STAFF REPORT
Docket No. SP-70-23
Summary No. 26301

The Waters at Promenade
Site Plan Review

Location: 4900 block of Promenade Blvd. Council District: 2
Legal Description: Proposed Parcel 6-A-4F, Bell Plantation Subdivision, bounded by Lapalco Blvd. and Barataria Blvd. PAB Hearing: 4/11/2024
Last Meeting Date for Council Action: 8/7/2024

FIGURE 9

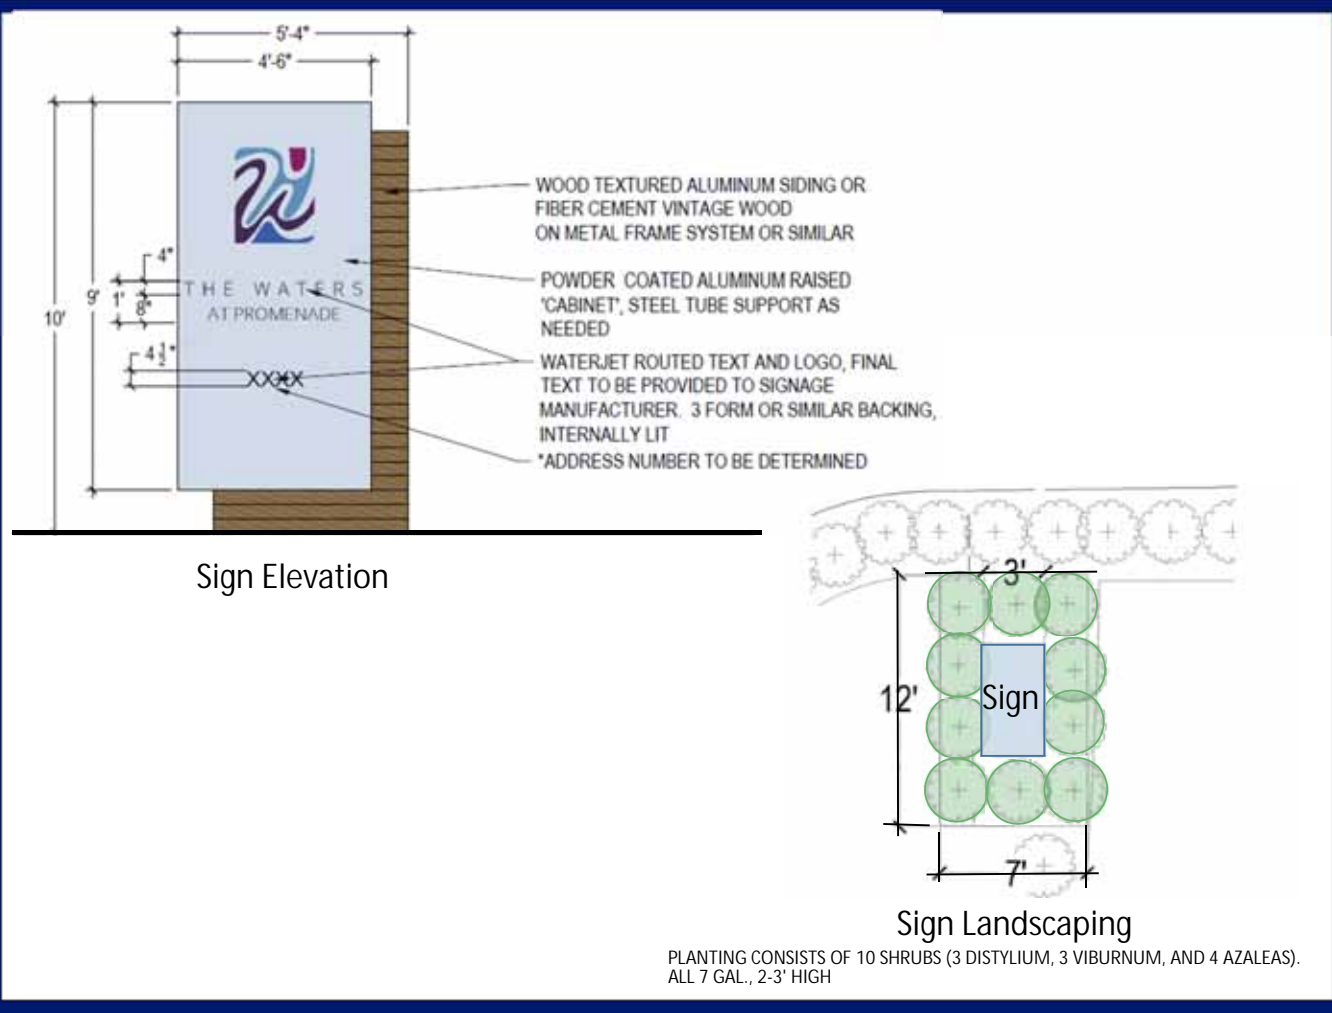
9. Sec. 40-448 *Sign Regulations-Detached signs* allows one (1) on-premise detached sign with a maximum area of one (1) square foot per linear of street frontage up to 200 sq. ft. The front yard is measured along Promenade Blvd. which has a width of 452 ft. The maximum sign height shall be 20 ft. One (1) 10 ft. high detached sign is proposed in this application. The sign has an area of approximately 41 sq. ft.; therefore, it meets this criterion (Figure 9).
10. The site plan meets the requirements stipulated in Sec. 40-447, MUCD General Design Standards (Table 4).
